Access Compliance Report

Public Rights-of-Way

(Curb Ramps)

Intersection ID: 9159	Main Street: CAMPUS_ST	Cross Street: TATE_ST	Location: NE
ADA ID: B73944F924D5	Ramp Type: Para	Initial Pass/Fail: Pass	Overall Compliance: No
Codes/Mitigation Info/Possible Solution			Severity Score: 15
			Field Measurements/Component Compliance

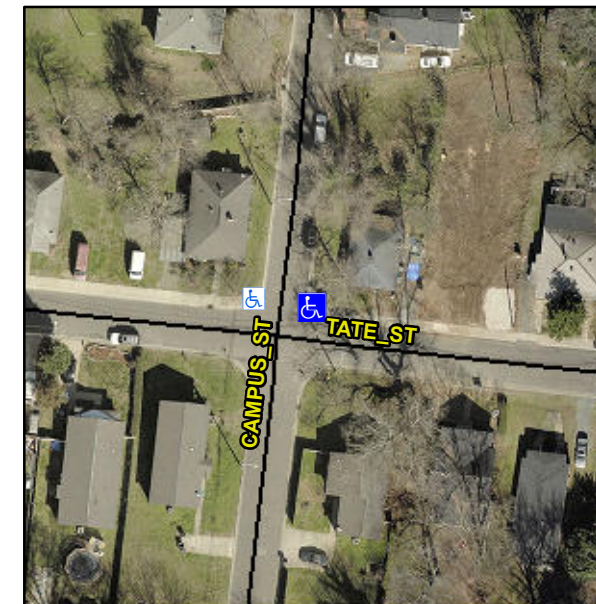
R304.2.1, R304.5.3, R305, R304.5.4

**Remove & Replace Entire Ramp.
Remove & Replace Gutter.**
